PLANNING COMMISSION
Regular Meeting
Monday, July 22, 2019
6:00 PM
Christine Nuernberg Hall

Agenda

TO: Planning Commission
FROM: JAC ZADER, ASSISTANT DIRECTOR COMMUNITY DEVELOPMENT
DATE: July 22, 2019
SUBJECT: PLANNING COMMISSION MEETING MINUTES from May 28, 2019

SITE LANDSCAPE
PLAN

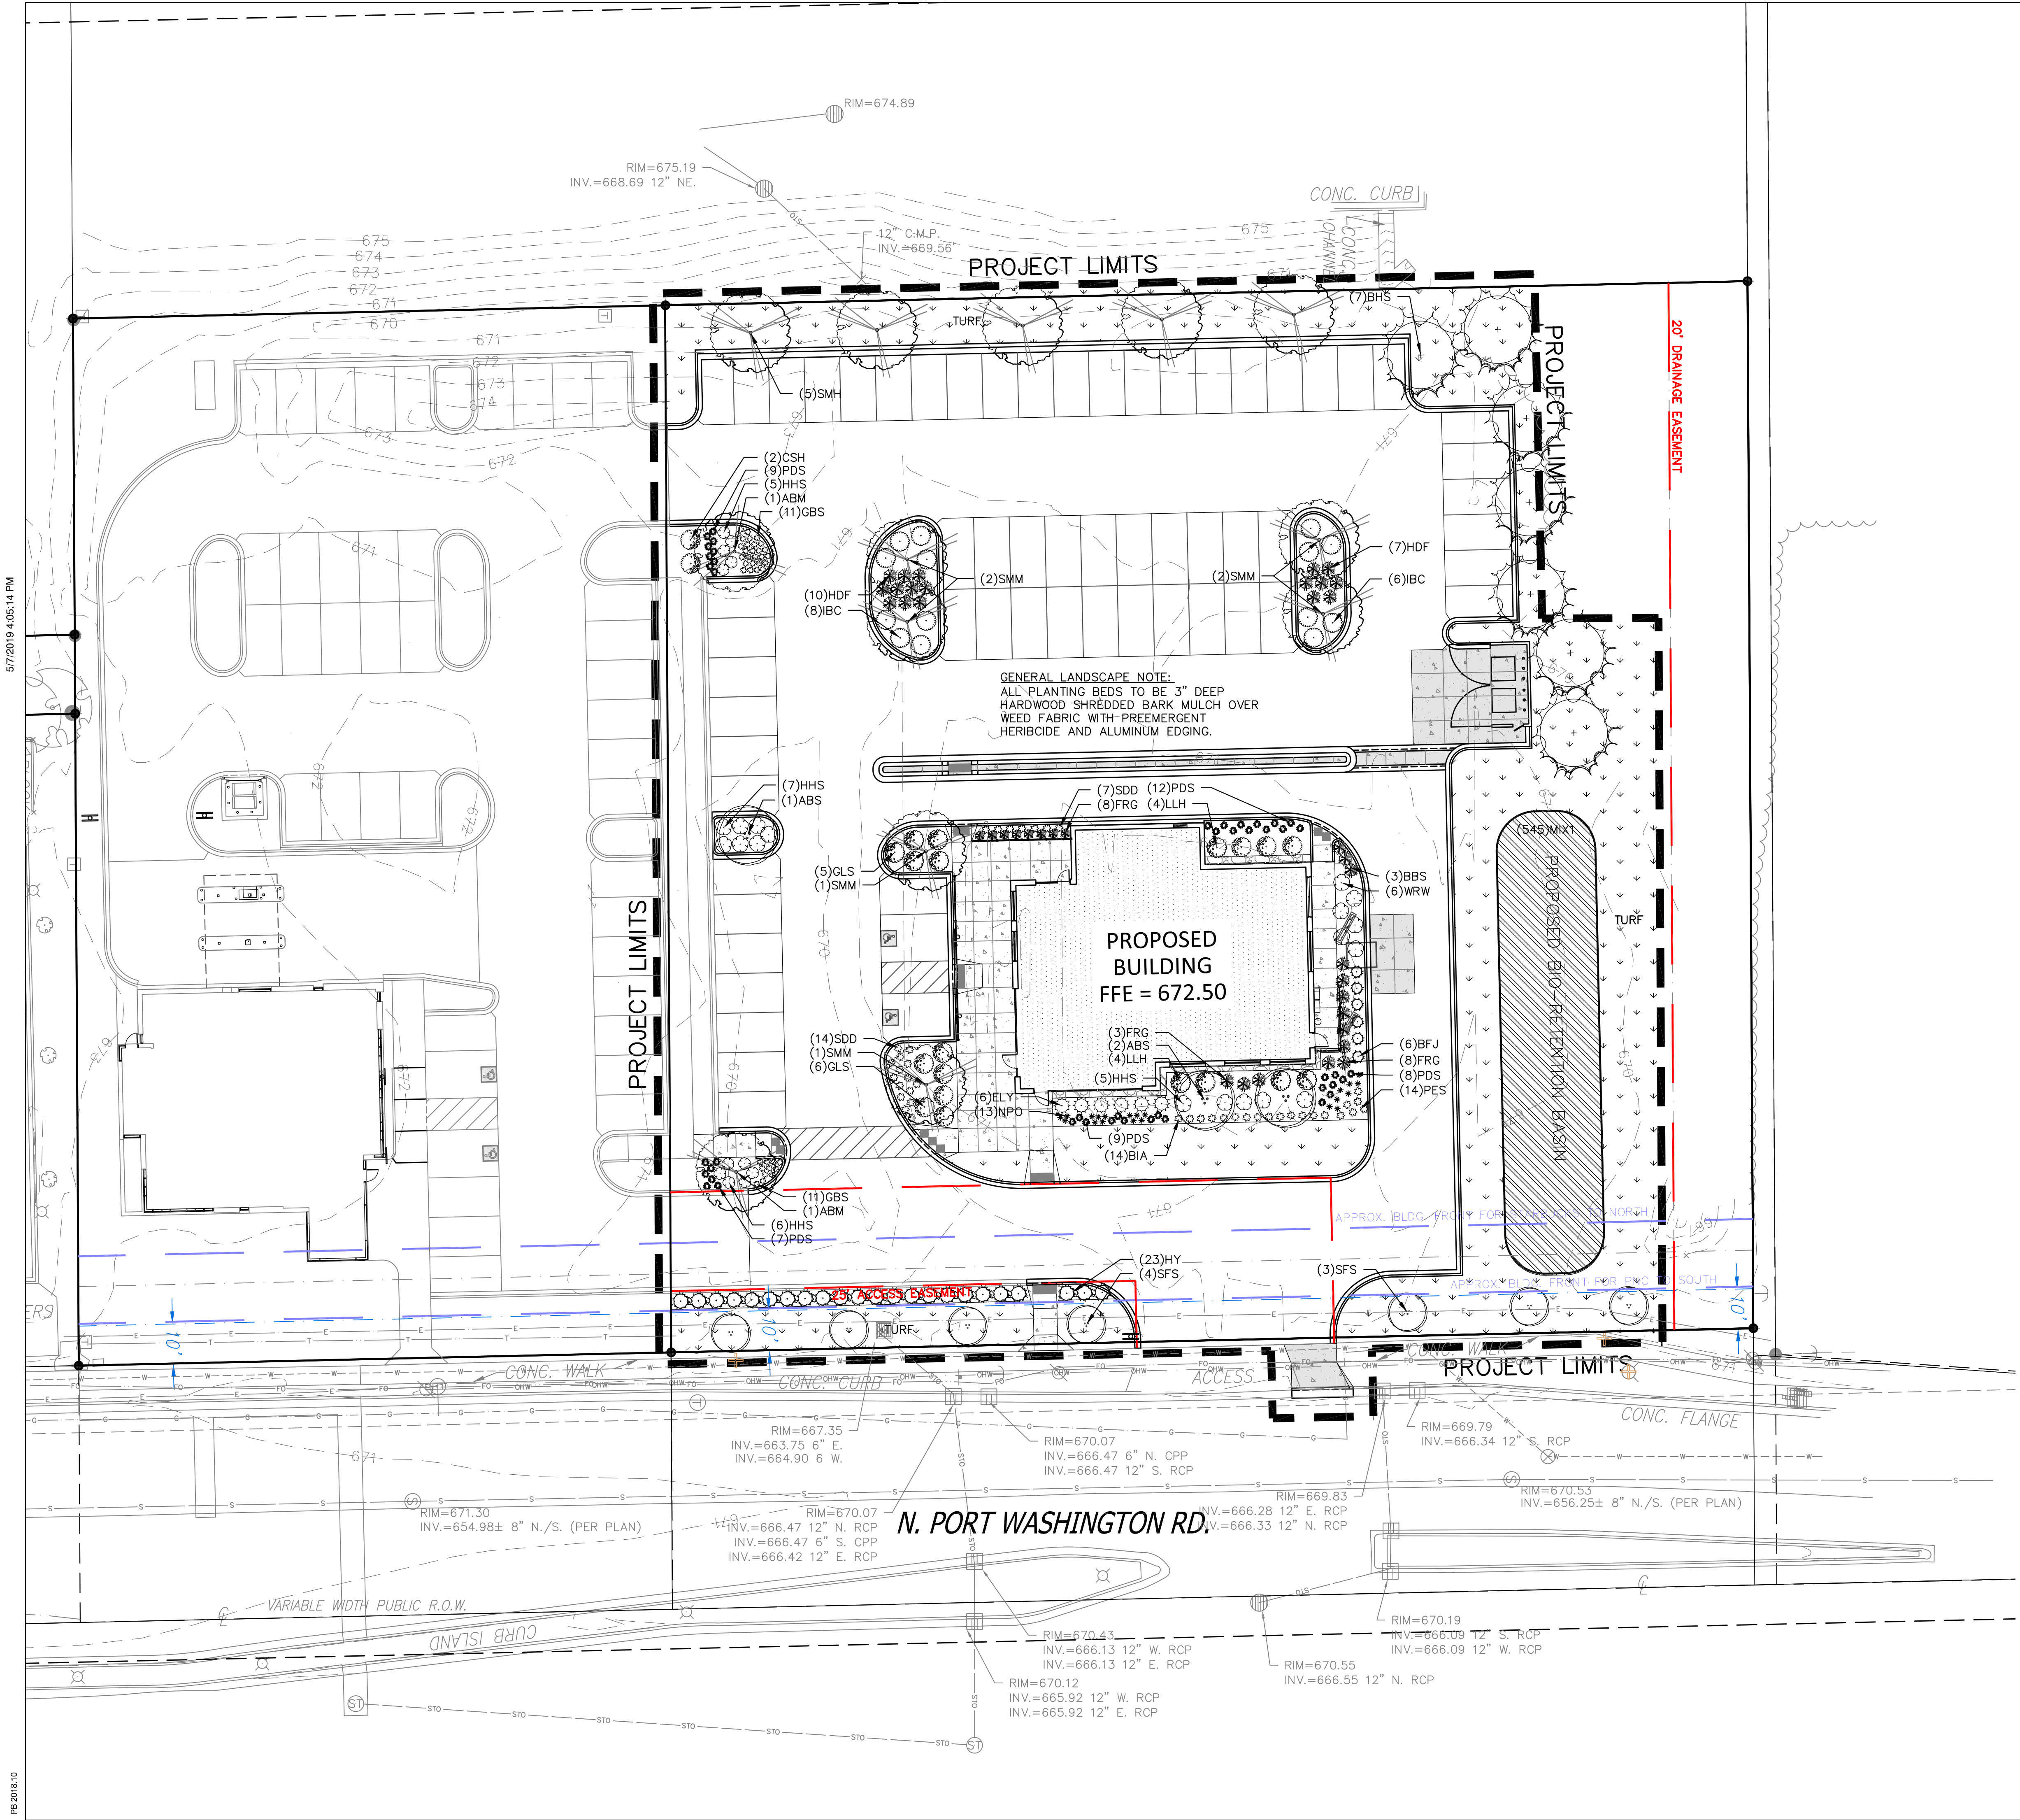
ensure all stock brought on sight meets the City of Mequon stated requirements. Multi stemmed Trees will have an equivalent diam root ball, height and a sum of leaders shall have a greater sum diameter area. Per ansi Z60.1, a 3.5" caliper large shrub w/ multi-trunk shall have a minimum height of 12-18 feet at planting. **Revise plant schedule to reflect the minimum plant sizes.**

EXHIBIT A

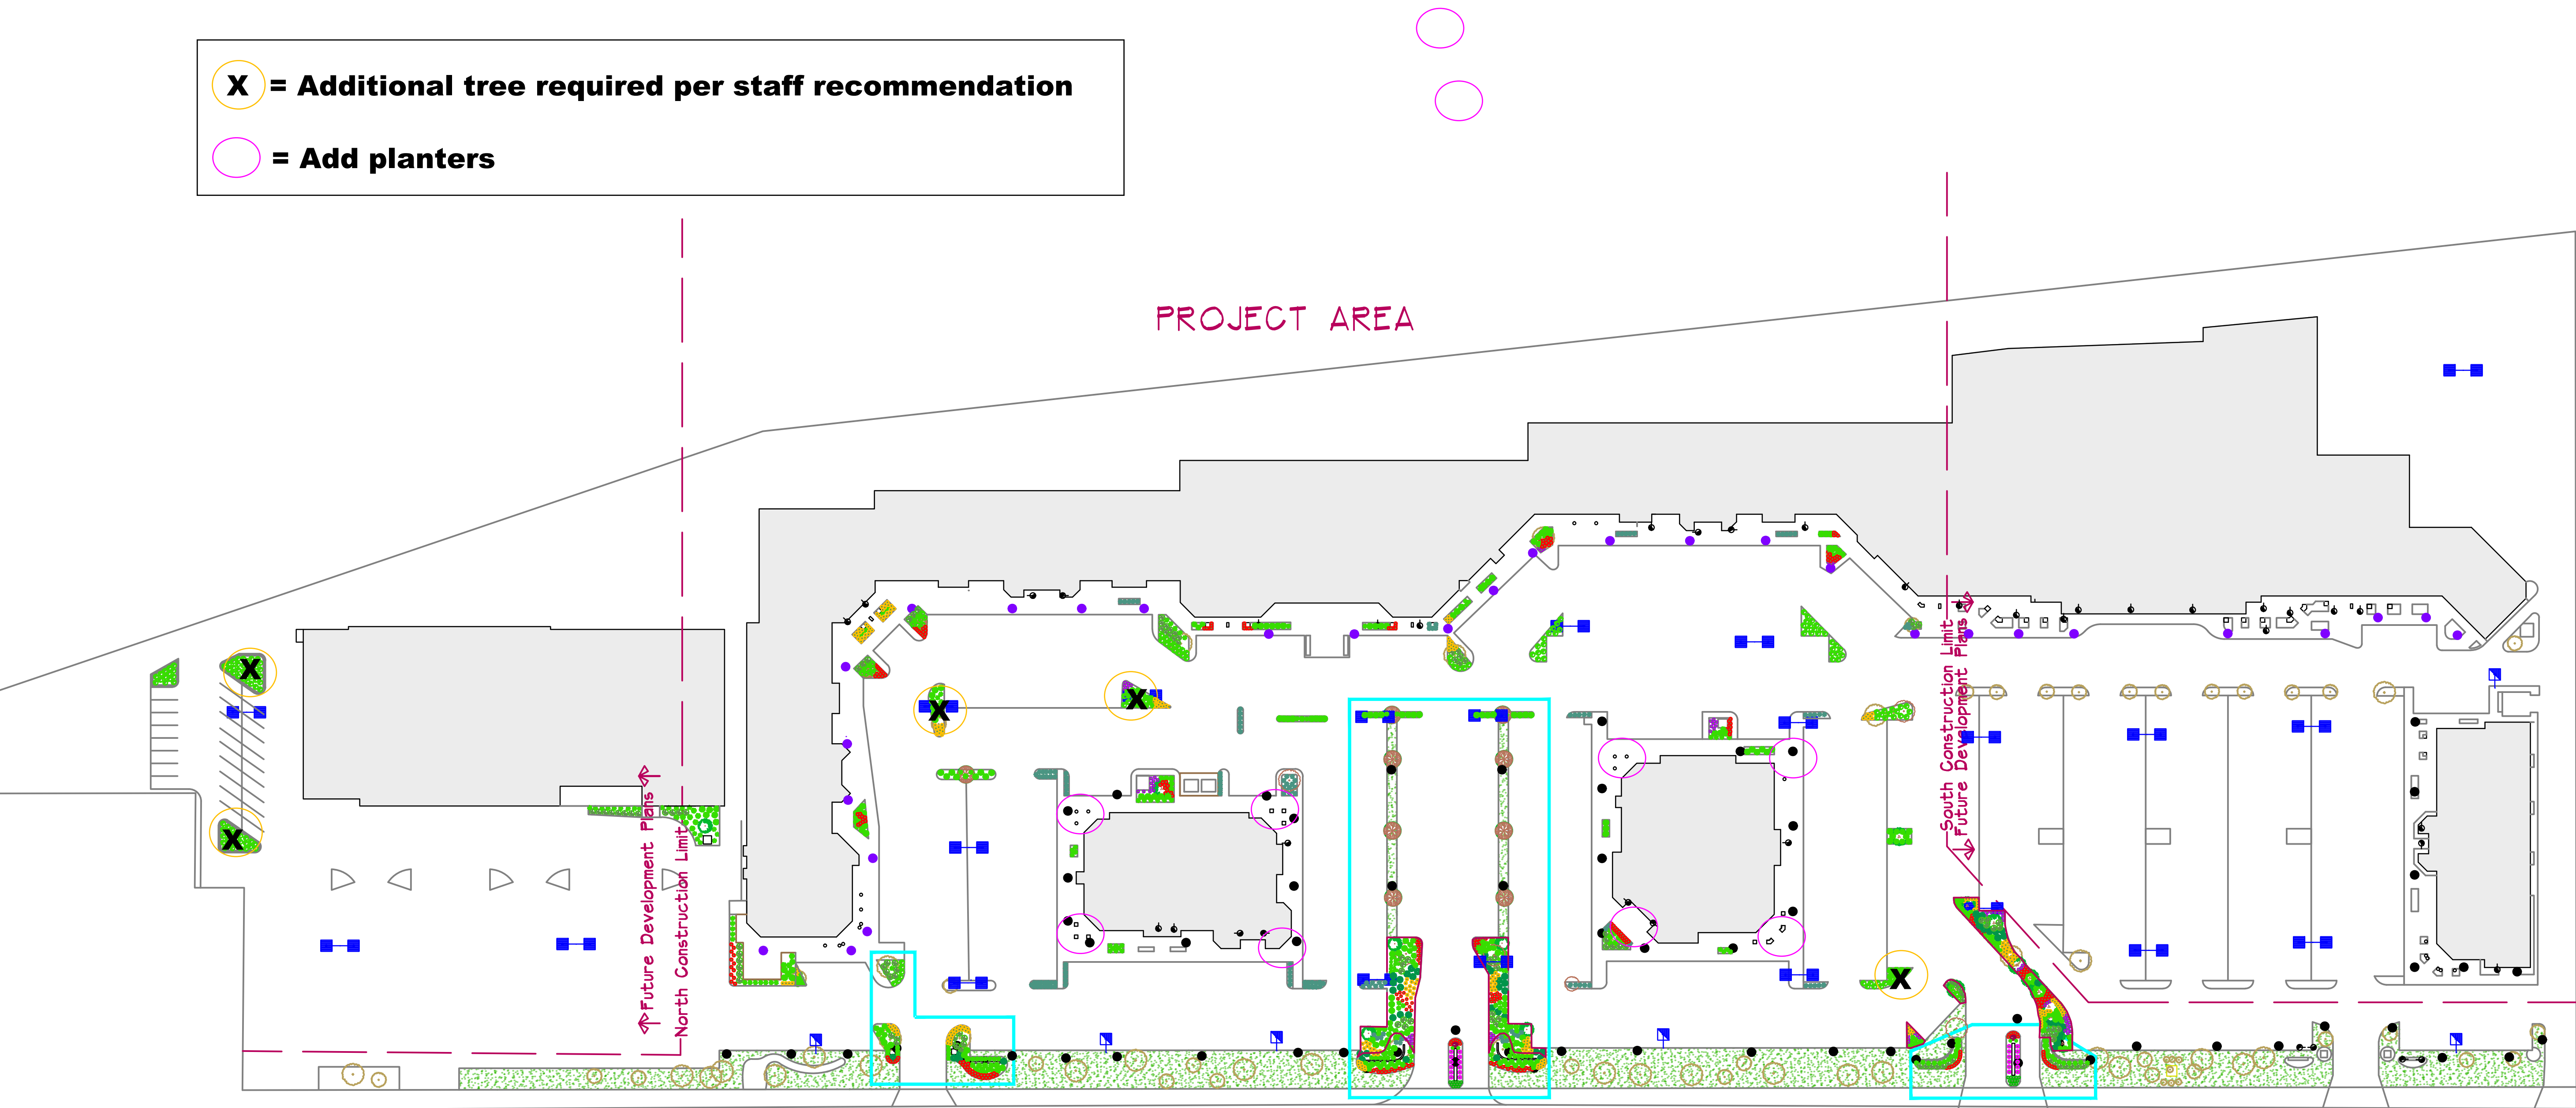
X = Additional tree required per staff recommendation
○ = Add planters
